UNITED STATES PATENT AND TRADEMARK OFFICE

APPLICATION NO.	FILING DATE	FIRST NAMED INVENTOR	ATTORNEY DOCKET NO.	CONFIRMATION NO.
10/711,281	09/07/2004	Chi Chang	12234-US-PA	5280

Office Action Summary	Application No.	Applicant(s)	
	10/711,281	CHANG, CHI	
	Examiner	Art Unit	
	Mohammad Timor Karimy	2815

FIG. 5b

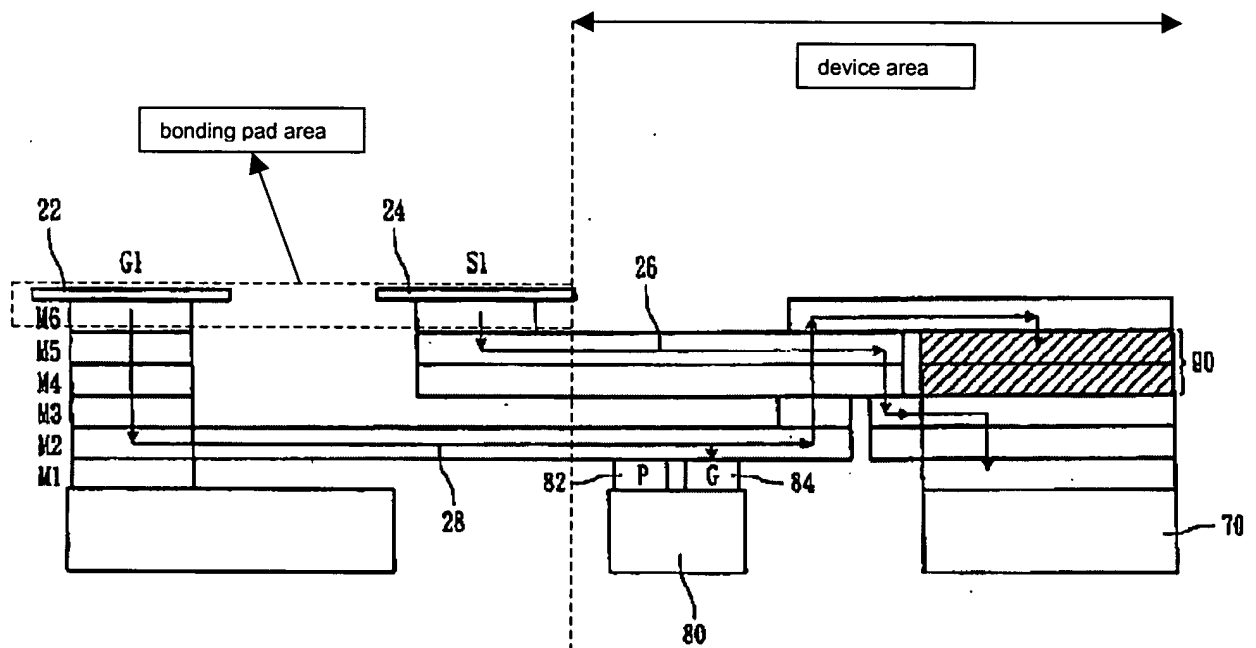
Cheng discloses in figures 5a-5b and in columns 5-6, a circuit layout structure for a chip with a bonding pad area (see figure 5b below), an adjacent device area (see figure 5b below), and a substrate comprising:

wherein the circuit layer farthest M5 from the substrate has a plurality of bonding pads (22, 24 and M6 in figure 5b) within the bonding pad area (show in fig.), and the

bonding pads close to the device area (24 and M6) **overstride** at least a non-signal circuit layer M2 (signal bus 26 overlaps non-signal bus power and ground bus) within the device area via the circuit layer farthest from the substrate (M5), and then electrically connects with the circuit layer closer to the substrate M1 through the via.

With respect to claim 2, Cheng discloses the circuit layout structure of claim 1, wherein the bonding pads **close** to the device area (24 and M6 in figure 5b or the plurality of inner row pads in shown in figure 5a) comprises a plurality of signal bonding pads.

With respect to claim 3, Cheng discloses the circuit layout structure of claim 1, wherein the bonding pad 22 farther away from the device area comprises a plurality of non-signal bonding pads (power or ground).

With respect to claim 4, Cheng discloses the circuit layout structure of claim 3, wherein the bonding pads 22 farther from the device area comprises a ground bonding pad.

With respect to claim 5, Cheng discloses in figures 5a-b, column 5 lines 20-23 and column 6 lines 10-13 the circuit layout structure of claim 3, wherein the bonding pads next to the farthest bonding pads from the device area comprises a power bonding pad (note that Cheng does not explicitly teach that bonding pad 21 being the farthest from the device area is the ground; however, Cheng teaches the power and ground arrangement in figures 5a-b, and Cheng explicitly teaches in column 6 lines 10-13 that bonding pad 22 which is ground in figure 5b can be used as the power bonding pad – one of the ordinary skill in the art would recognize such an arrangement making the farthest bonding pad 22 as the ground and the bonding pad next to the farthest pad as the power bonding pad).

circuit layer and the part of the Nth circuit layer within the device area forms a direct electrical connection with the bonding pad closest to the device area (the Nth circuit layer is M5 in figure 5b).

With respect to claim 9, Cheng discloses the circuit layout structure of claim 6, wherein the bonding pad next to the closest bonding pad from the device area (note 22 in figure 5b) is electrically connected through the (N-1)th circuit layer to the Nth circuit layer within the device area (see fig. 5b above).
